Re: Green Necklace - Jones to Grand Boulevard

The HUB North Shore committee has reviewed the Open House #1 Conceptual Plan for the Green Necklace: Jones Avenue to Grand Boulevard and supports the City of North Vancouver's ongoing commitment to building facilities that encourage cycling.

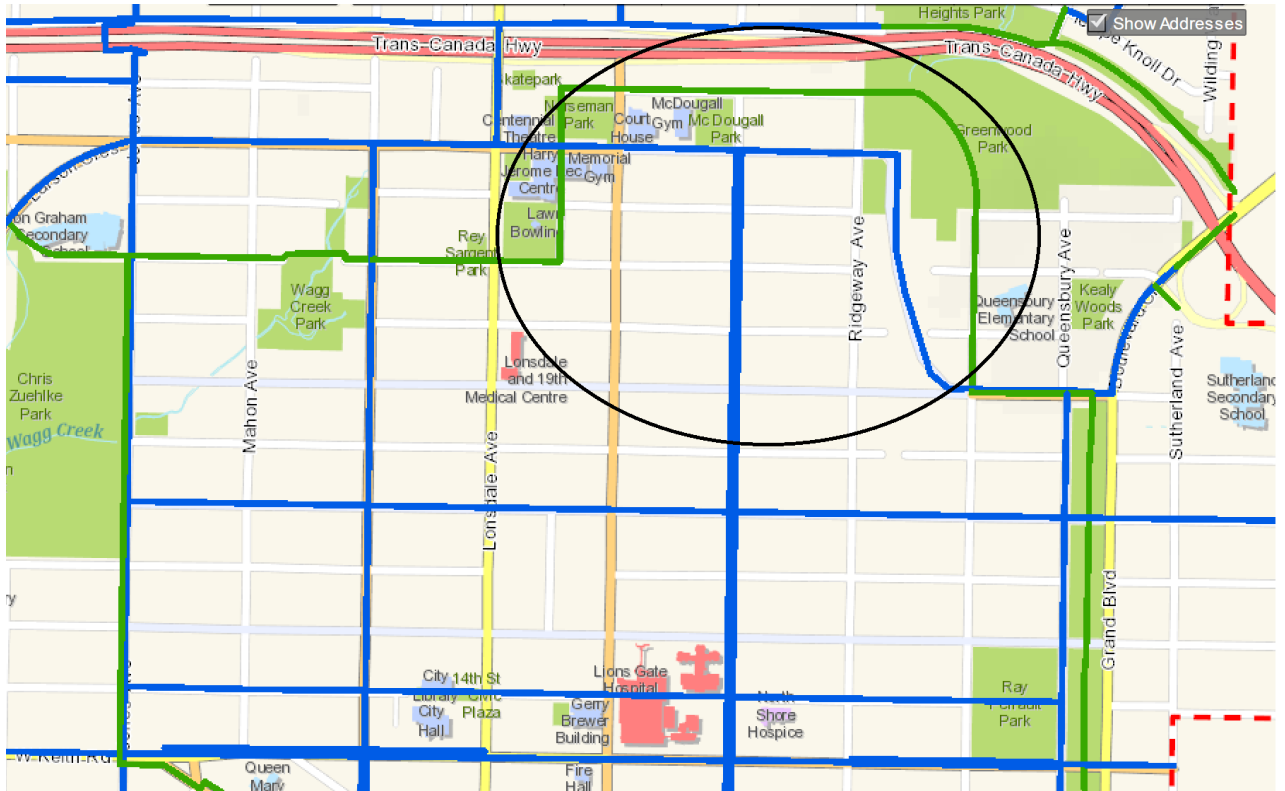
The trail over the bridge/hill from Wagg Creek to Chesterfield will need to be at least 4m wide and appropriately sloped for cyclists to get up and down safely and easily. The conceptual plan notes that in this area it will be difficult to provide universal access. We hope that a flyover structure might mitigate the slope in this area for both cyclists and people with mobility challenges.

Map #2 AAA Bicycle Network from City Web Site

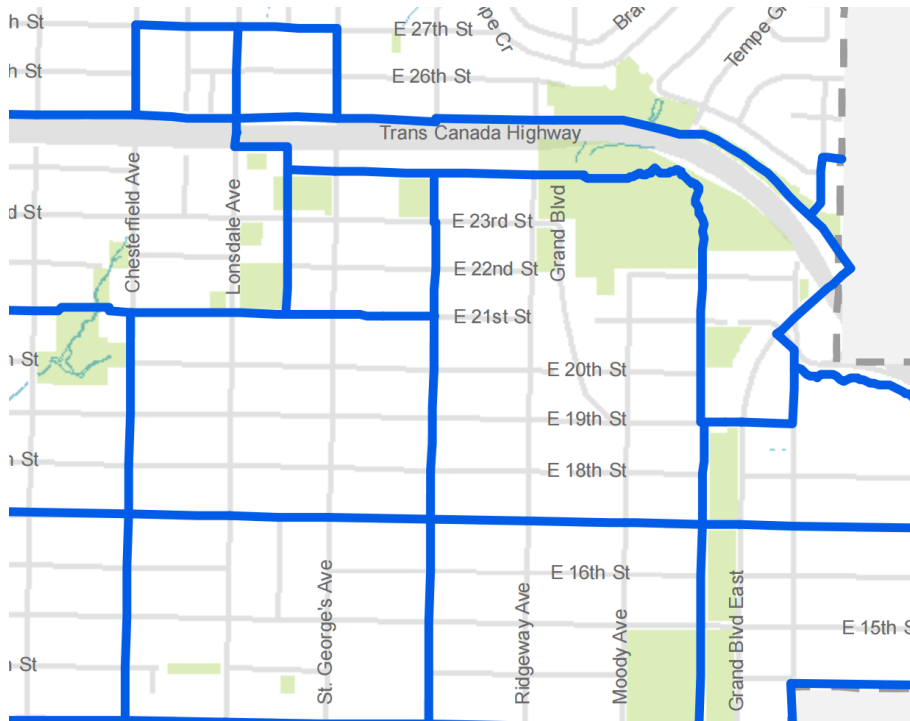
The following map is from the AAA network map posted on the City web site. In this depiction, the AAA route follows the off-road route above.

HUB is concerned that there is a lack of clarity regarding which route will be AAA, and whether cycling facilities are the Green Necklace or run parallel to the greenway. The 3-metre-wide, multi-use Green Necklace is too narrow to accommodate all users safely and comfortably, including seniors and young children (walking or cycling), people with poor hearing or vision, and people who bike at faster speeds such as on downhill grades or when using ebikes. We are very concerned that proper safe cycling facilities cannot subsequently be incorporated into a street space made too tight by projects like the Green Necklace as has occurred on Jones Avenue and E Keith Road.
